REMARK

AMENDMENTS -- MARKED VERSION

Presented below are the amendments with markings to indicate changes made.

FIG. 6A

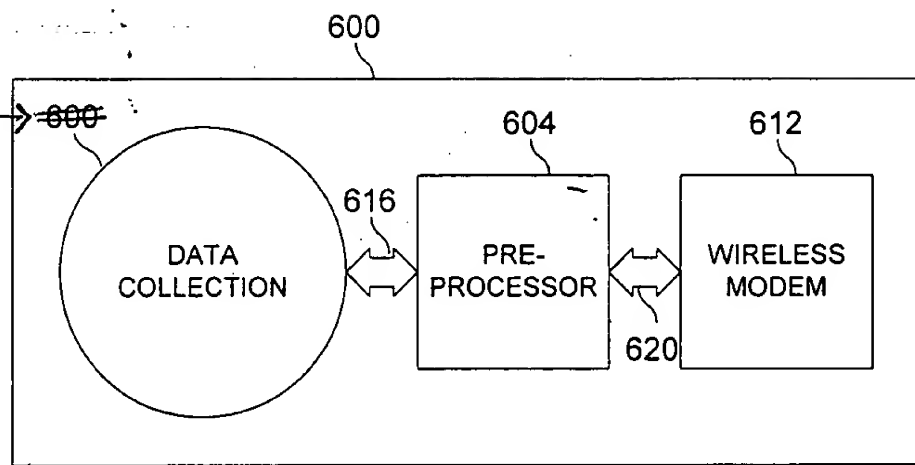
Figure 6A - The reference number for the data collection unit has been changed from “600” to “608”, as is indicated in the description of the drawing in the specification.

FIG. 13B

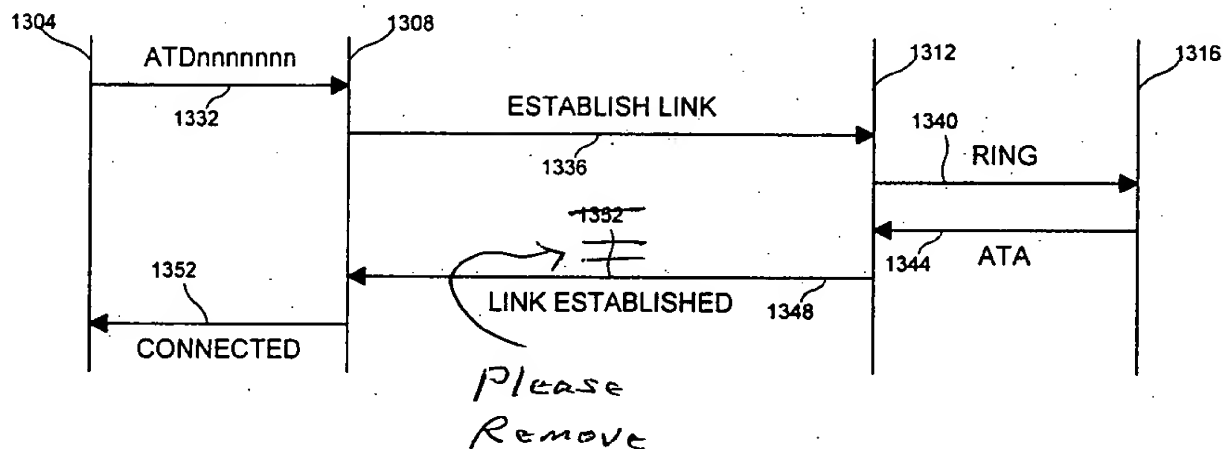
Figure 13B - An extraneous reference to element 1352 has been removed.

FIG. 13C

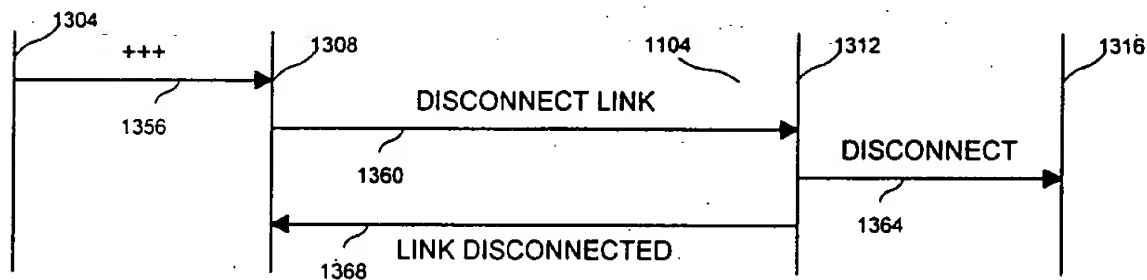
Figure 13C - The reference “1350” has been added for the process illustrated in Figure 13C.
